Architectural Commission Report

Meeting Date: Wednesday, February 20, 2013

Subject: **CANON CLUB**
342 North Canon Drive
Request for approval of a façade remodel and outdoor dining elements and business identification signage including a sign accommodation (PL1302003)

**J DETAIL - BUILDING SIGNAGE / BUSINESS NAME / DESIGN SCHEMATICS CLERESTORY WINDOW
 SCALE: 1" = 1'-0"**

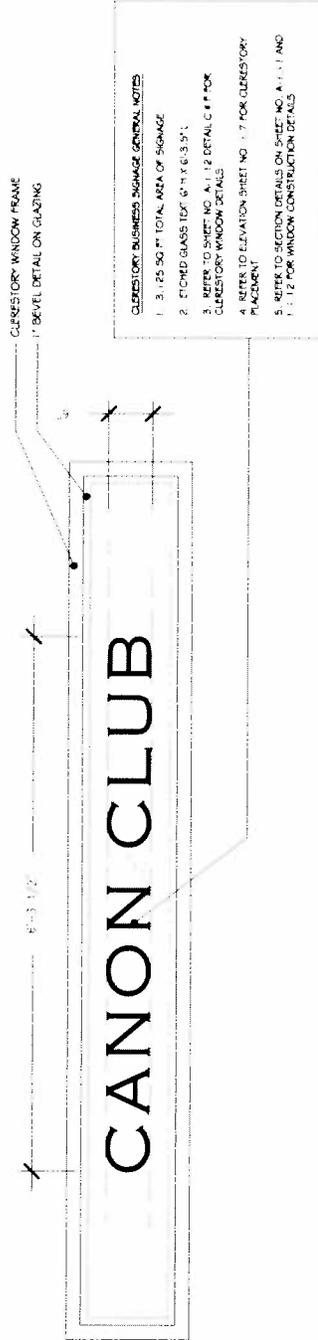
- Business ID sign: One 5 SF sign is proposed to be etched into the clerestory glass above the storefront with the copy "Canon Club."
- A matching address sign is proposed to be etched into the glass above the entry door.
- Awning sign: One 7.5 SF sign with two lines of text (total height 13.5") with the copy "Canon Club / Restaurant and Bar" is proposed on the projecting awning/deck face. A sign accommodation is requested for this sign.

As proposed, the business ID sign complies with the standards set forth in the BHMC. A sign accommodation is requested for the awning sign since it is located on an awning that projects more than 12" from the face of the building and contains more than one line of text. Sign accommodation. The Architectural Commission may approve a sign accommodation to allow letters in more than one line or exceed seven inches (7") in height if the combined height of the letters and symbols in all lines and the spaces between the lines does not exceed fourteen inches (14") on a marquee, awning, canopy or similar architectural element which projects more than 12" from the face of the building. As proposed, the awning sign
